適航指令發布單
Airworthiness Directive Issuance Form

設計國AD編號 Original AD number	2026-20-10Correction

[Docket No. FAA-2026-2712; Project Identifier AD-2025-00931-T; Amendment 39-23483; AD 2026-20-10]

Airworthiness Directives; The Boeing Company Airplanes; Correction

Figure 2 (Sheet 1 of 3) Slat and Flap Inspection

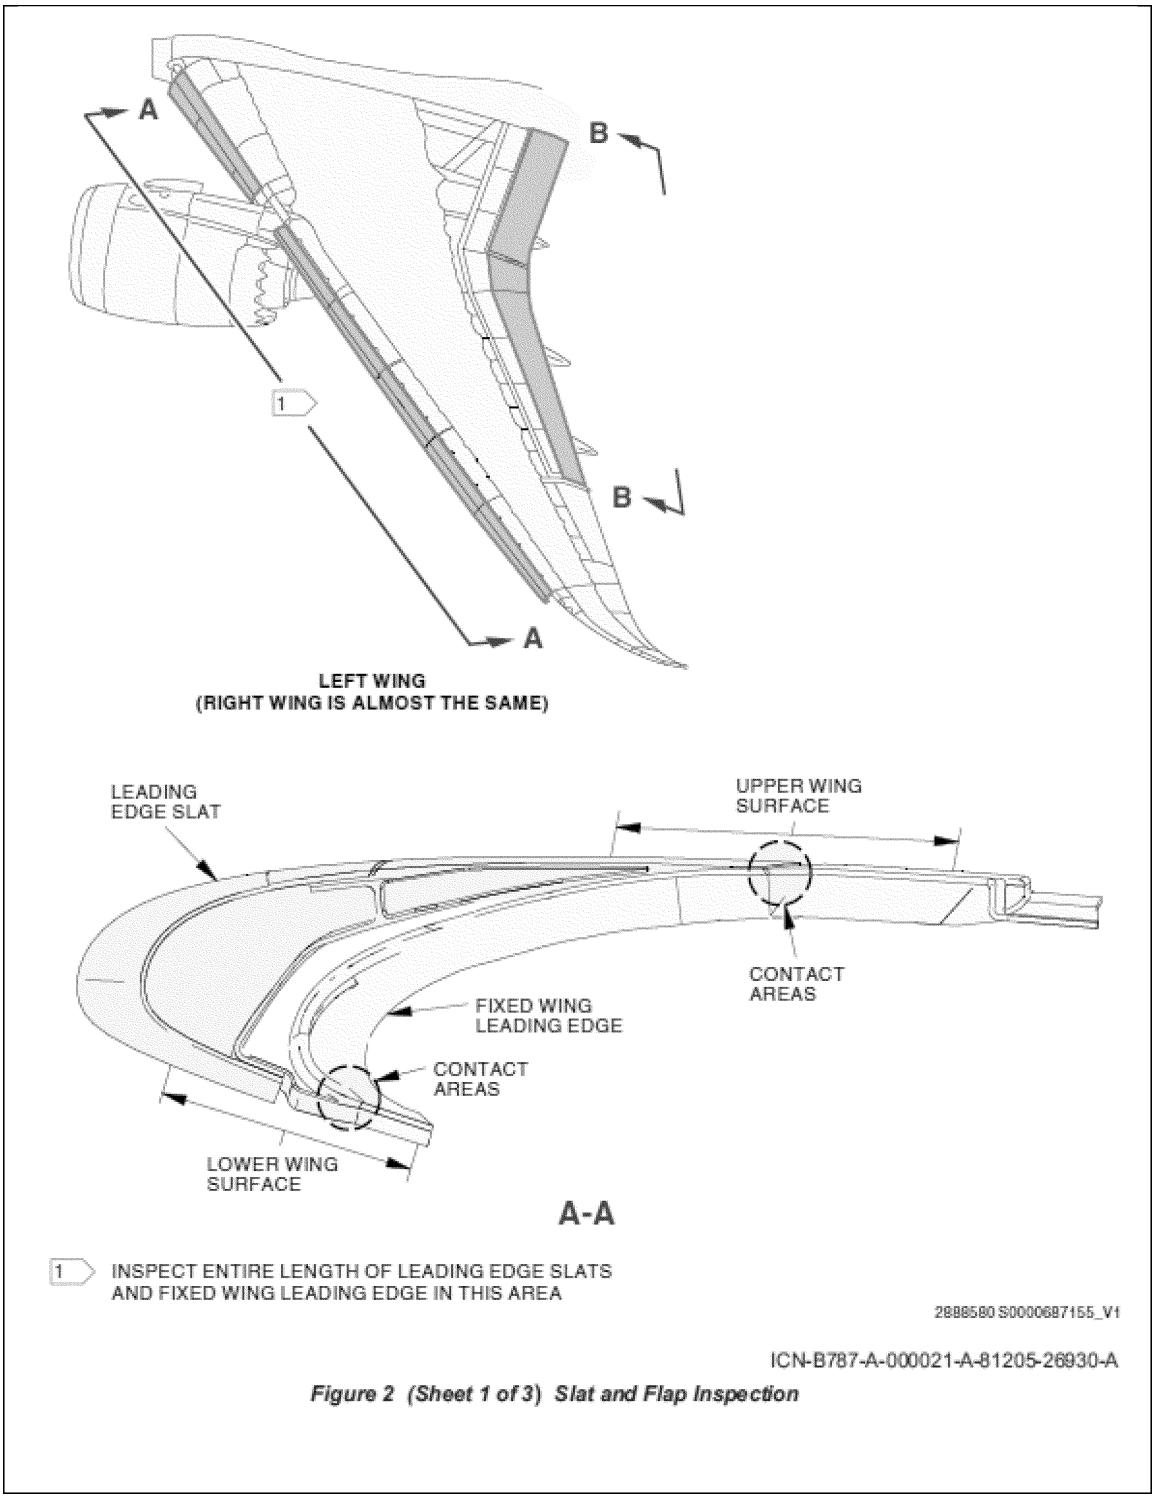
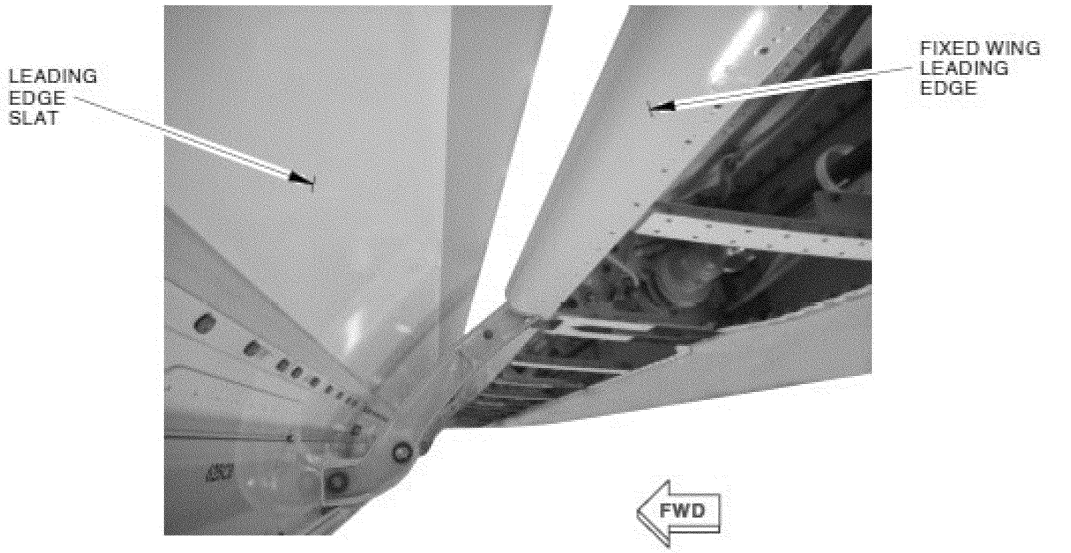
This paragraph restates the requirements of paragraph (j) of AD 2019-20-07, with no changes. Within 60 days after October 11, 2019 (the effective date of AD 2019-20-07), revise the existing maintenance or inspection program, as applicable, to incorporate the information specified in figure 2 to paragraph (j) of this AD. This may be done by inserting a copy of figure 2 to paragraph (j) of this AD into the existing maintenance or inspection program.

After any landing in icing conditions, do this inspection with the slats/flaps (flaps 25 detent) fully extended (Figure 2):

Figure 2 (Sheet 2 of 3) Slat and Flap Inspection

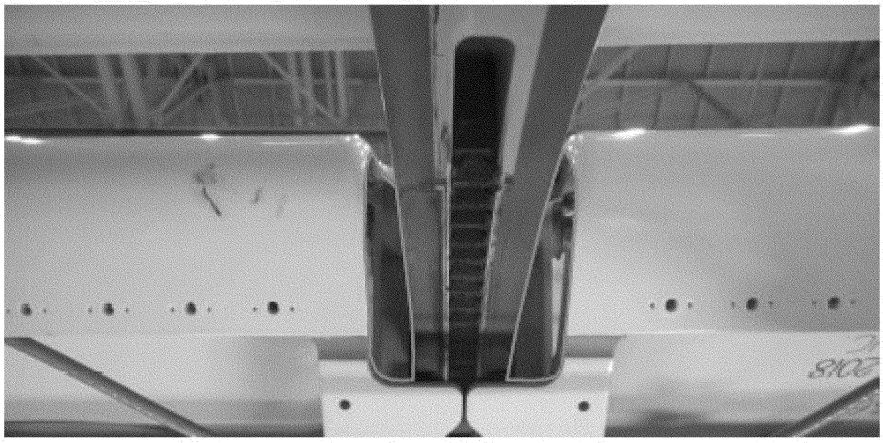
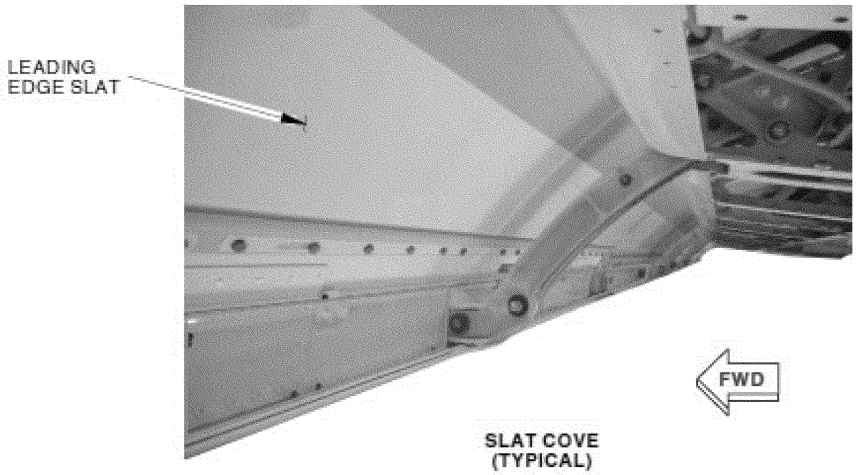
(3) Slat actuation areas, including exposed areas of the slat track cavity, and slat cove

Figure 2 (Sheet 3 of 3) Slat and Flap Inspection

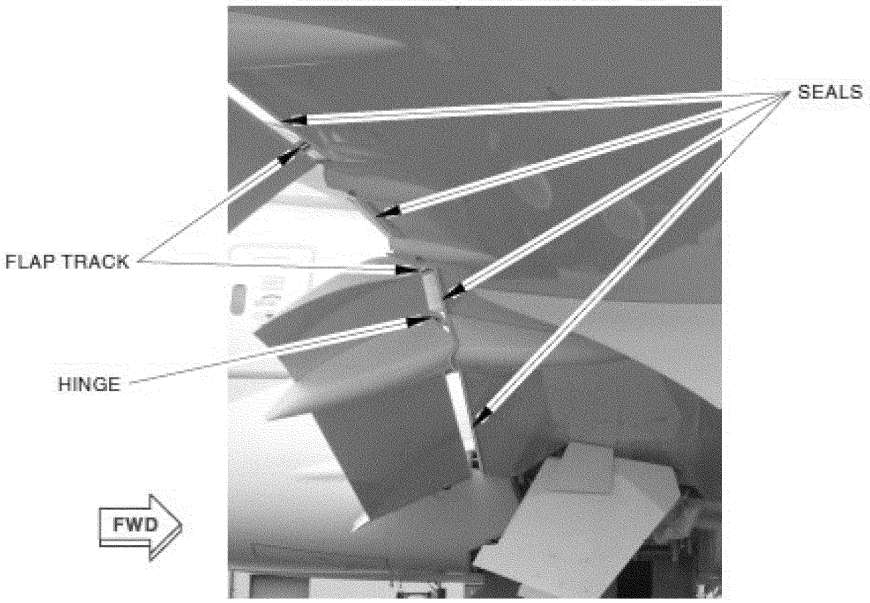
(4) Flap tracks, hinges, seals
